TECHNICAL BULLETIN

Document: TB_T318_004

Subject: Front suspension bracket

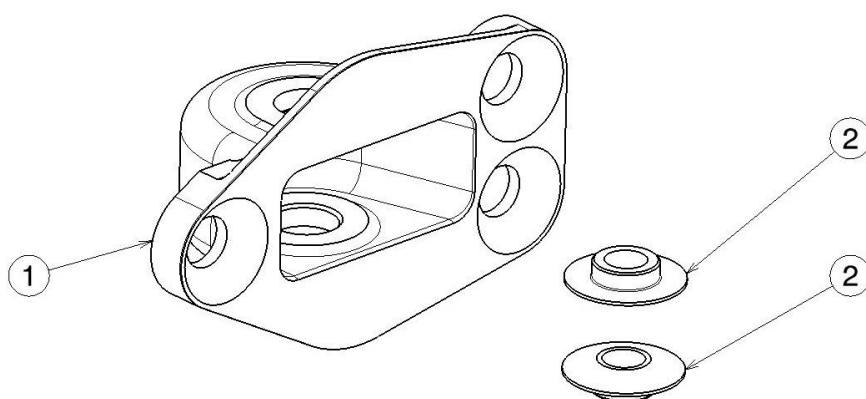
Tatuus is providing a replacement for the front bottom suspension brackets 24 10 031.
The new item engraved with pn. 24 10 043 (or 24 10 044) must replace the existing pn. 24 10 016.

We remind you that the tightening torque of the fixing bolts (UNI5933-M8x20) must be set at 35Nm:

Subject: Front wing hangers

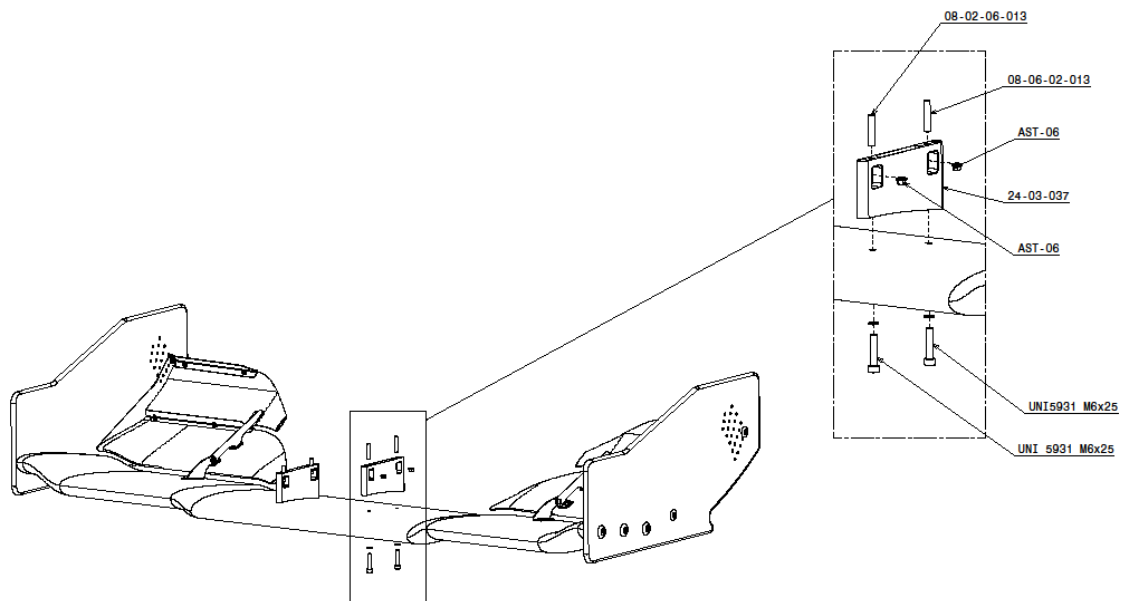
Tatuus is providing a replacement for the front wing hangers.
The new item (24 03 037) must replace the existing pn. 24 03 009 and 24 03 010.

Subject: Front upright lower arm bracket bush

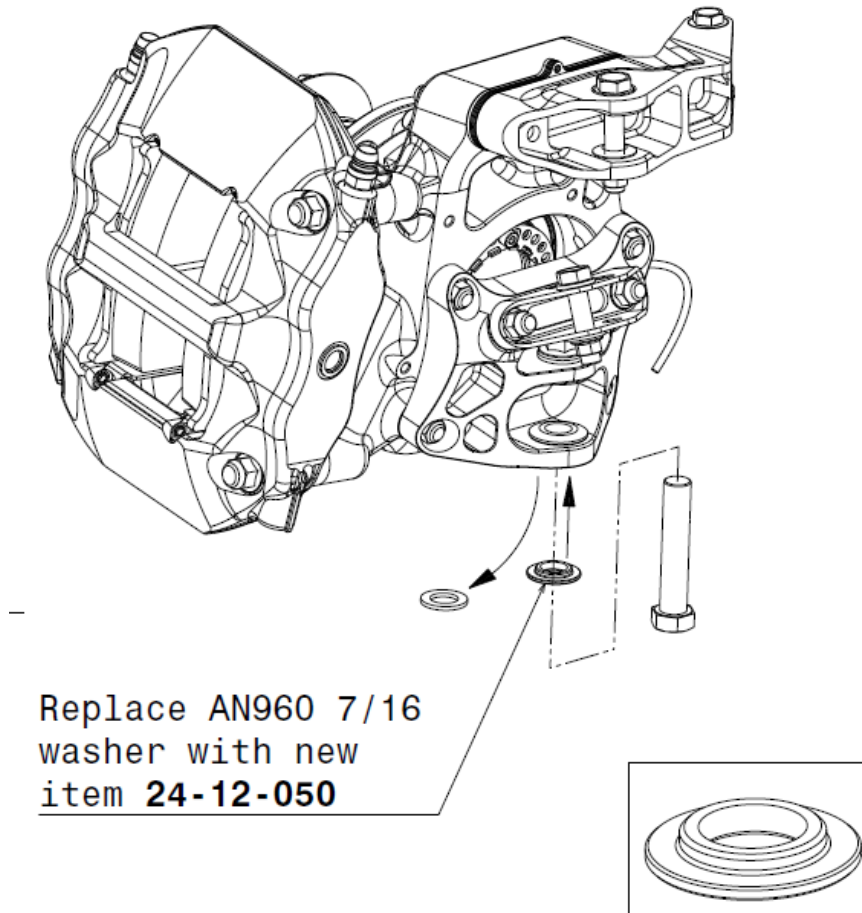
Tatuus is providing a replacement for the AN960 7/16 washer.
The new item (24 12 050) must replace the existing washer.

Subject: Wheel retaining locking pin

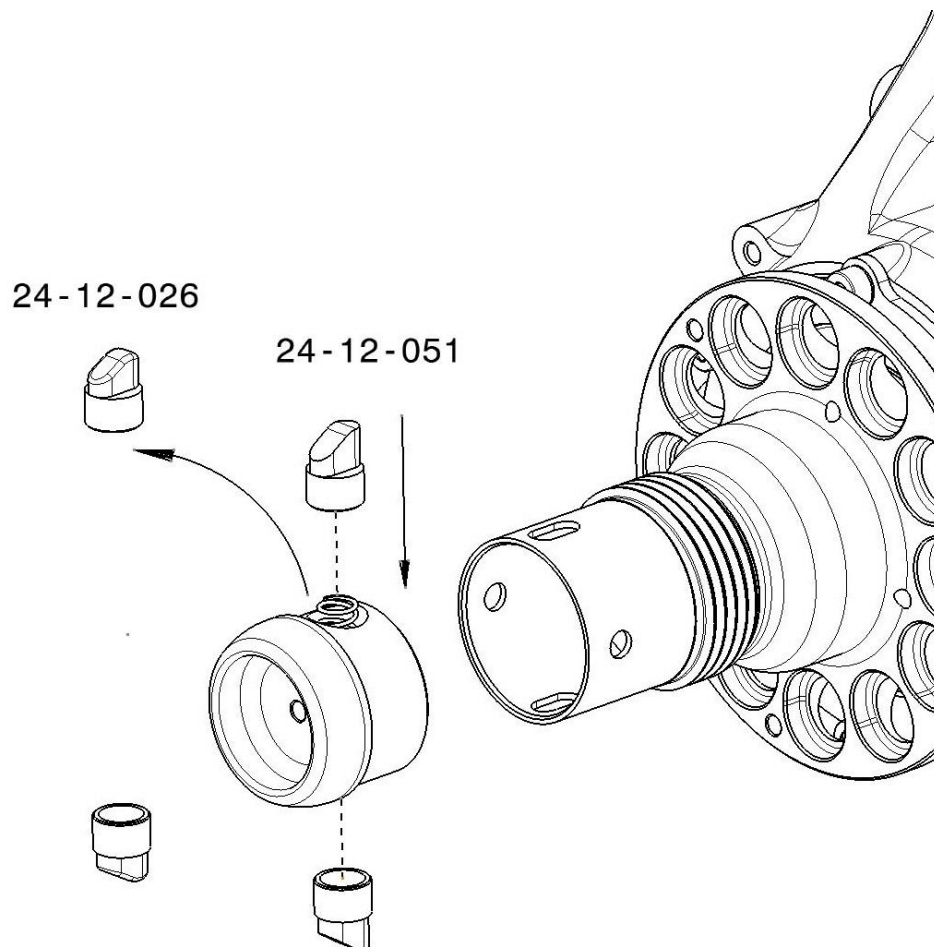
Tatuus is providing a replacement for the 24 12 026 wheel retaining locking pin. The new item (24 12 051) must replace the existing spec.

Subject: Front anti rollbar blade modification

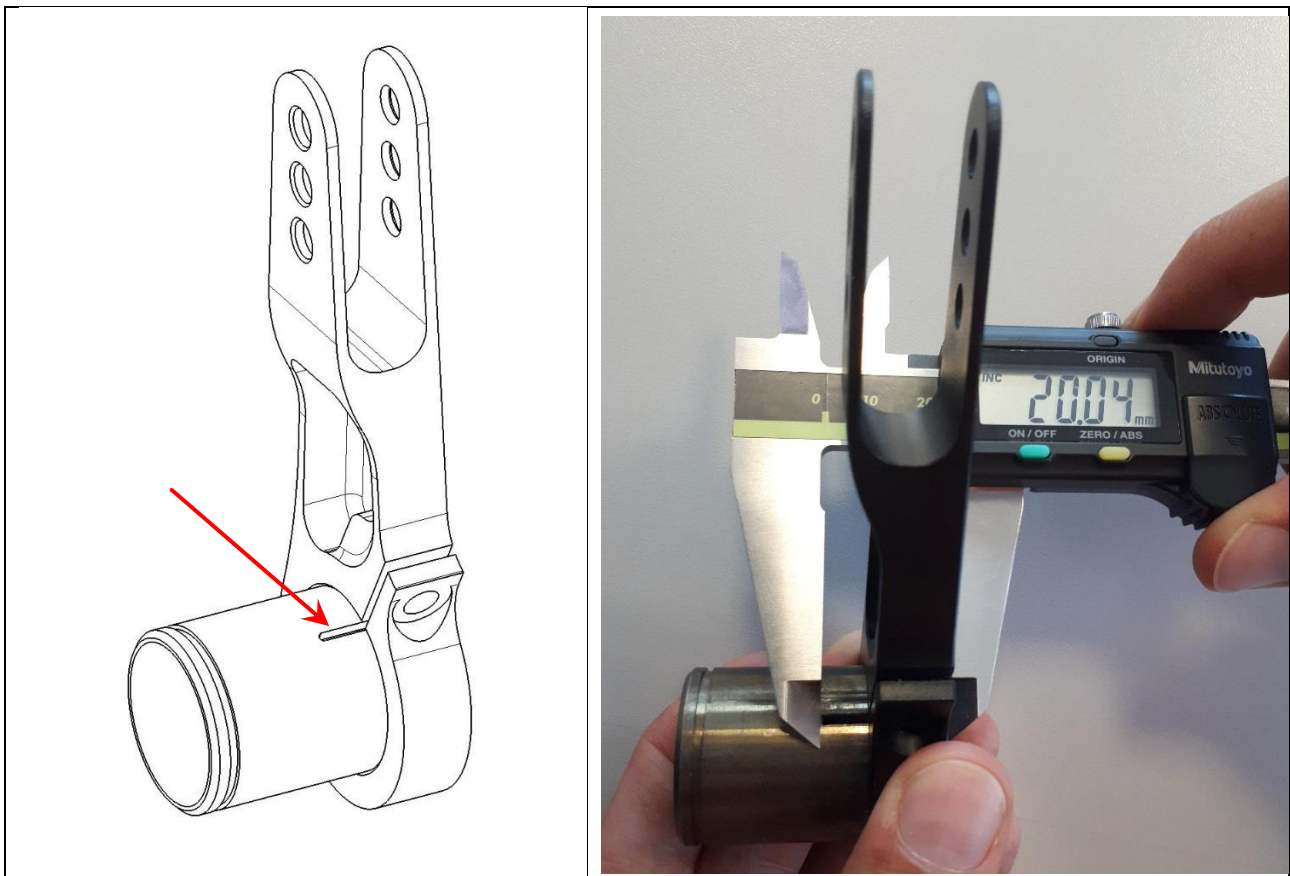
Teams are invited to check the length of the cut on the front anti rollbar blade.

The length should be 20mm (+/-1mm) from the side end of the blade.
If it is less than 20mm, teams are allowed to modify the cut to bring it to the correct dimension.

Subject: Belleville for differential preload setup

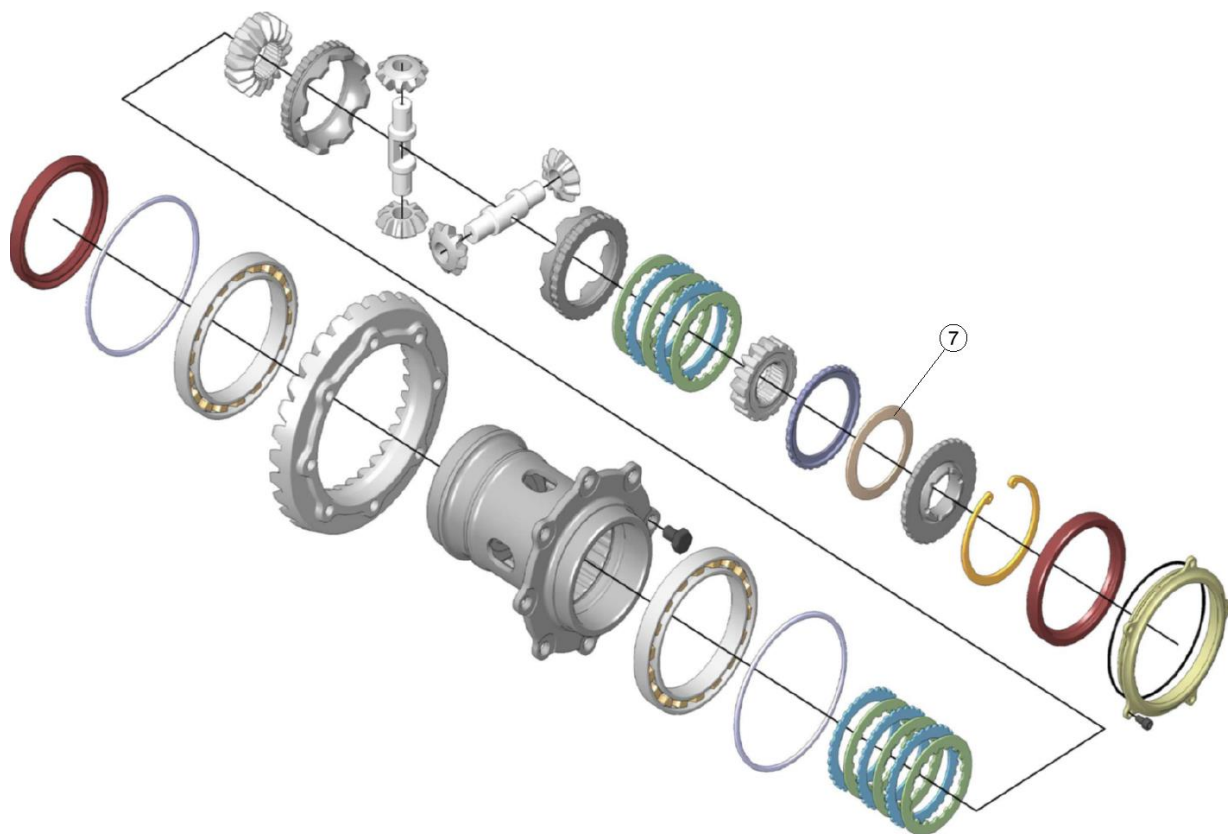
A list of allowed alternatives for the differential Belleville washer is authorized.

For the item 7 in the picture above it is allowed the alternative use of the parts listed below

Part number	Description
F1910313	Belleville 0.8 mm
F1910314	Belleville 1.0 mm
F9046326	Belleville 1.2 mm

Figure 1

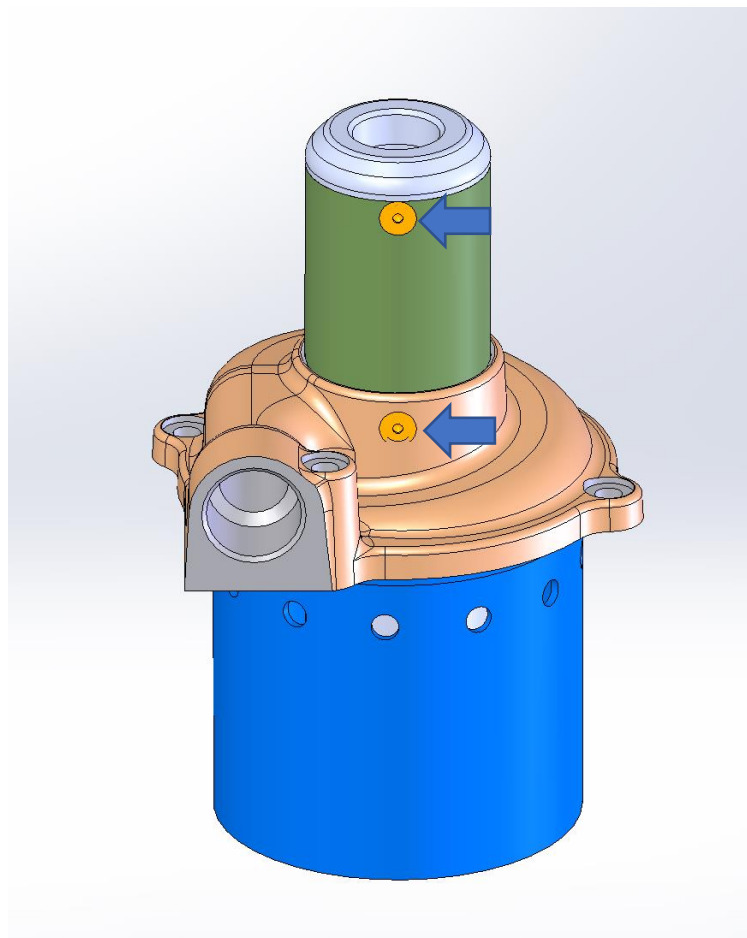
Teams are allowed to apply two rivets in order to strengthen the bonding between the swirl pot parts. Please refer to the figure below, the relevant rivets are shown.

- rivets: blind, 120° countersunk head, sleeve \varnothing 4.0 mm, shank 11.0 mm. Sleeve material Aluminium
- glue: 3M DP 460.

Figure 2: position of the countersunk holes on the oil swirl pot assy for blind rivet nut application

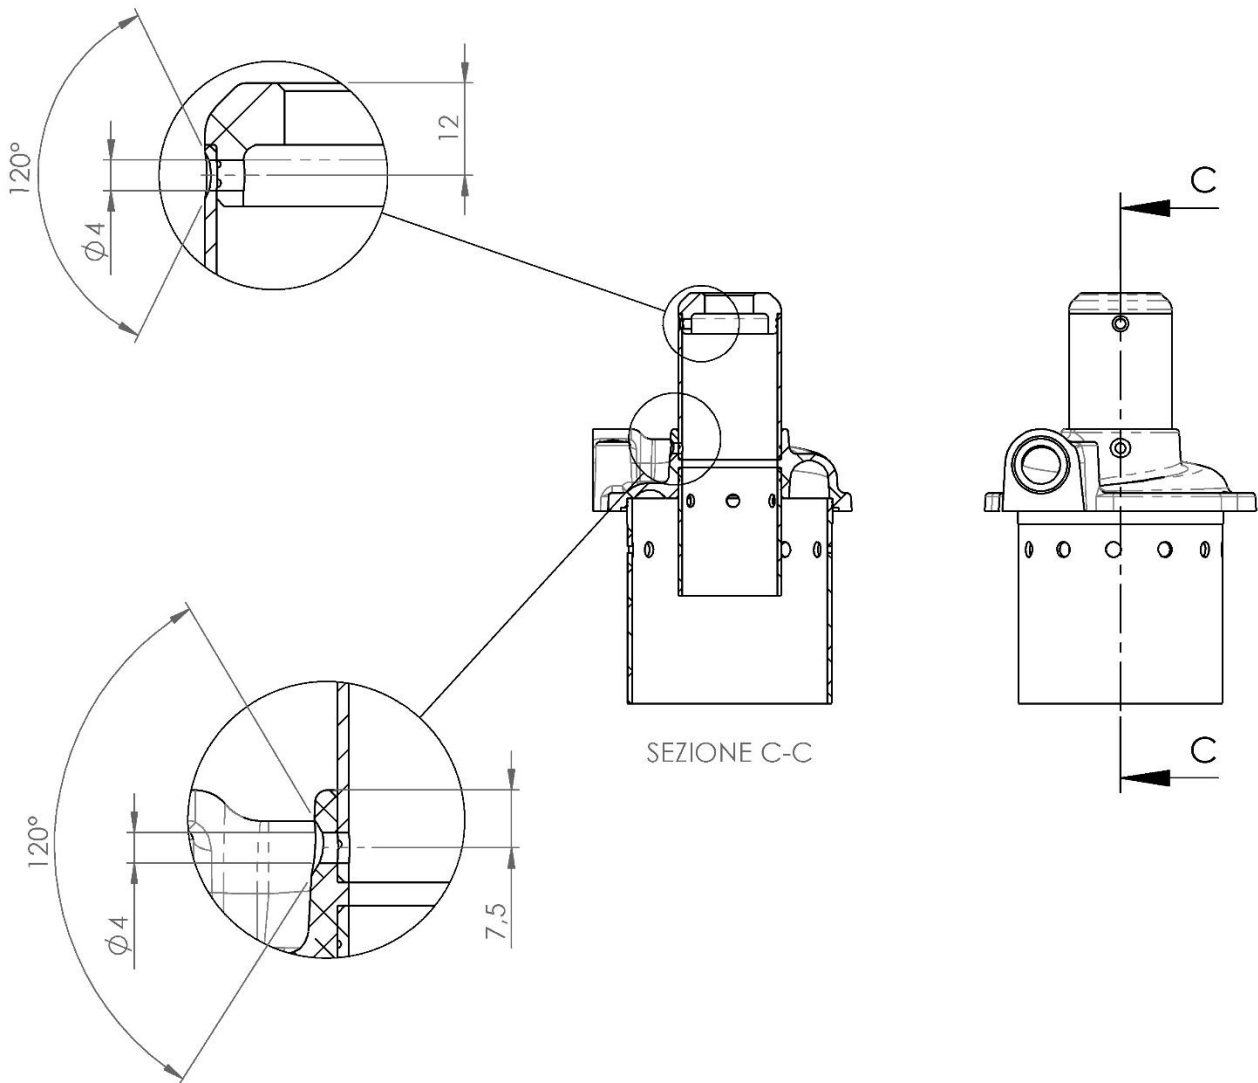
In order to apply the rivets, the oil swirl pot assembly must be drilled. Please find in the drawings below dimensions in order to place the rivets in the correct position.

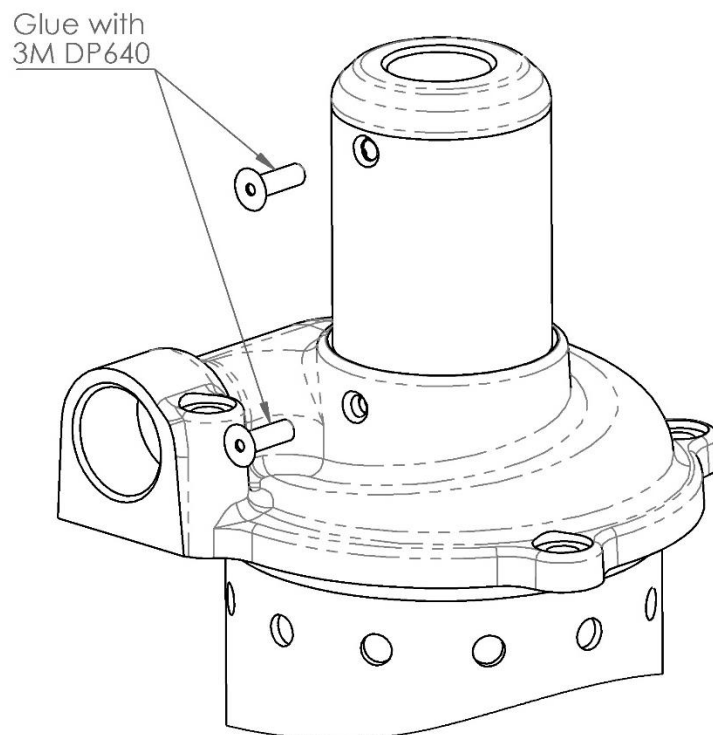
Please pay attention to the depth of the countersink. It should be deep enough to assure that the head of the rivet is tangent to the surface. Please refer to the picture below

Document: TB_TW18_018
Date: 16/09/2019
Subject: Diffuser cut-out for Pirelli tires

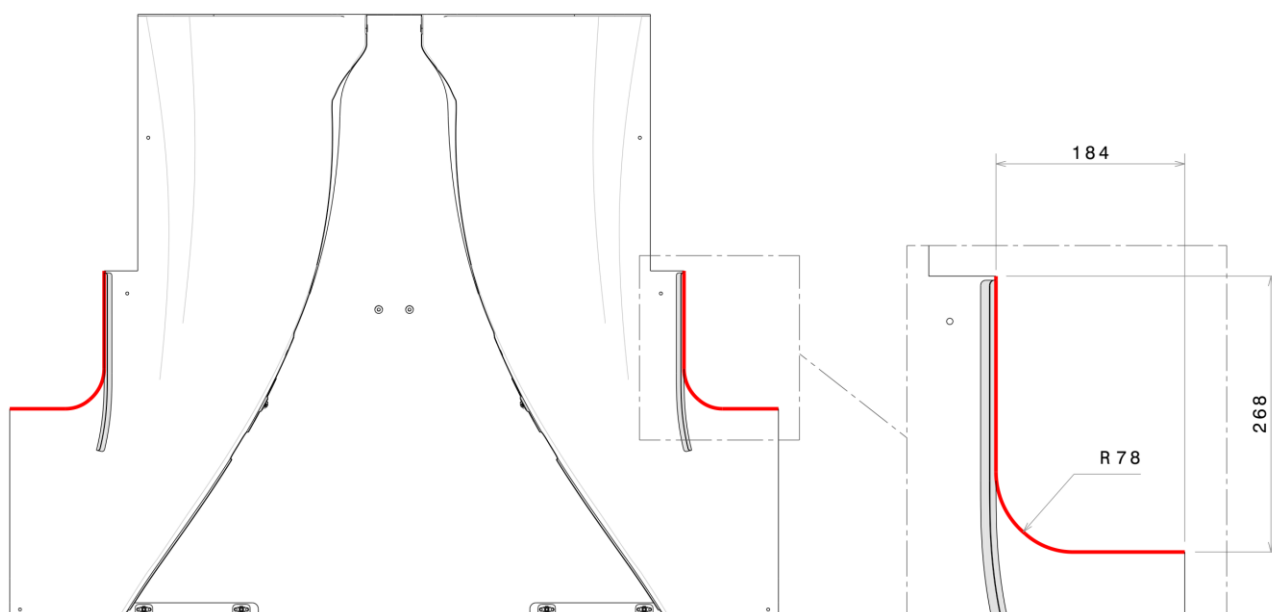
Due to tires rubbing on the diffuser noted after Imola 2019 WSK races, for all the Championships using Pirelli tires the diffuser's tires cut-out will be modified into a deeper one.

Teams have to update their cutting profile using the jig (code: 2493069) that will be available at the Tatuus' and Championship Organizer's truck.

The use of *Elan-tech® ADH 891.892* Epoxy adhesive (black) to seal the cutting profile is suggested.

Subject: Steering rack and pinion

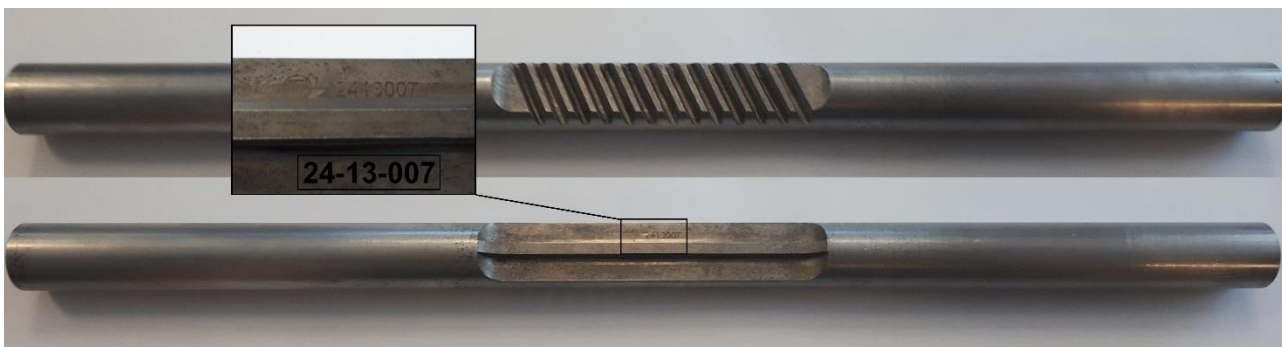
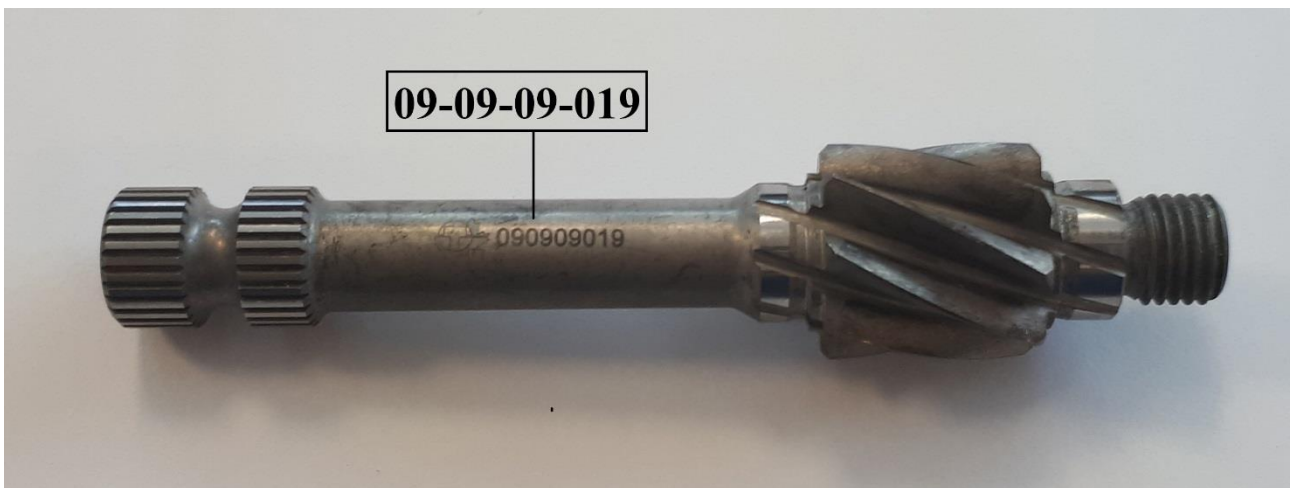
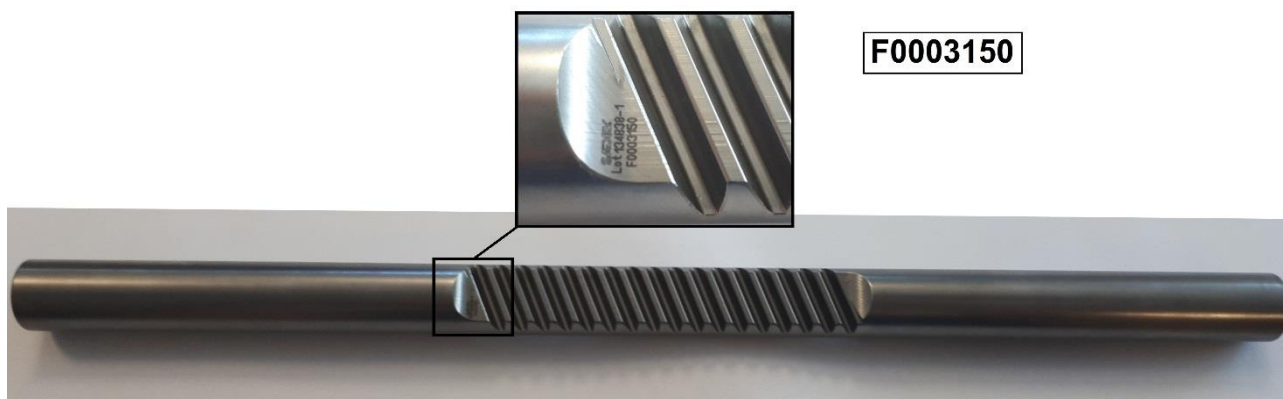
The following components had a laser marking variant:

The alternative marking codes are:

Tatuus recommends to pairing laser marked 24-13-007 only with 09-09-09-019 and F0003150 only with F0003022.

Figure 1

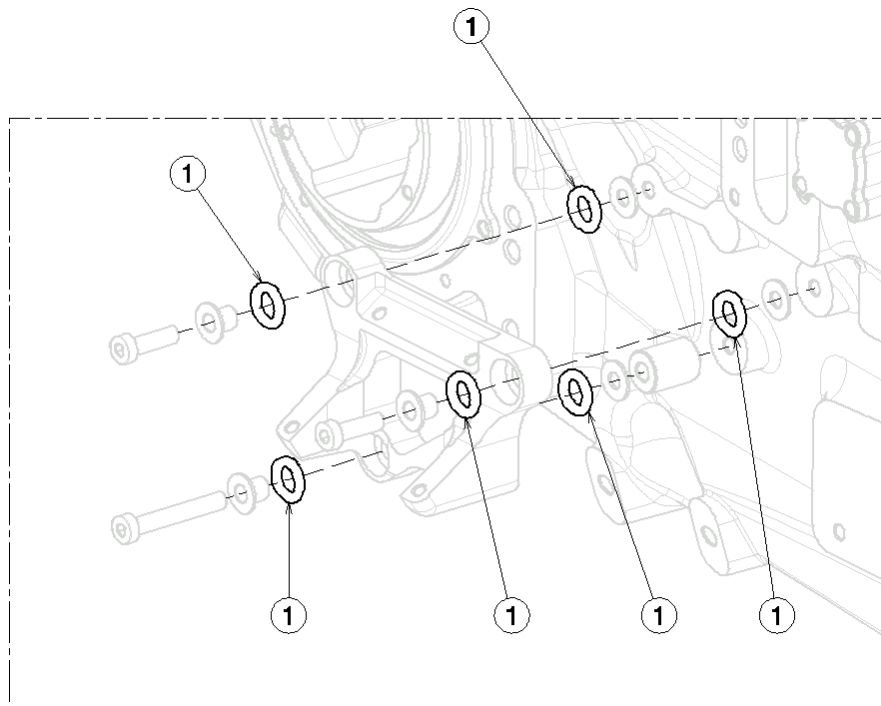
The shifter actuator (ESA) is installed on AV mounts. The AV installation is realized with specific rubber rings, please refer to the elements with #1 in the picture below.

The rubber ring (p/n ORN4036) should be inspected each 1000 km and must be replaced before 3000 km.
